MODEL **991036**

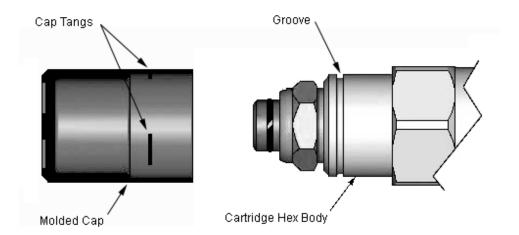
Sun Hydraulics introduces a new style of tamper resistant cap for Series 1 cartridges. The deep drawn metal can (zinc plated steel) has been replaced by a black Delrin®, injection molded cap. This new design is easier to install, more tamper resistant and does not corrode. All of Series 1 products with a 'C' control are currently being shipped with the new style tamper resistant cap. The pressure setting must be specified at the time of the order and the setting will be stamped on the cartridge hex. For kit purchases, the new injection molded cap must be used with a cartridge body that has a retaining groove cut into it. For cartridges manufactured prior to June 2004 or for customers uncertain of which cap is applicable, combination kits are available including both caps. Note: Sun's existing metal can may be used on cartridges with or without the retaining groove.

• To install, press the cap onto the cartridges's hex body until a snapping sound is heard. Do not force the cap to bottom out against the top of the hex. A small gap should remain. Pull back on the cap to verify a successful installation.
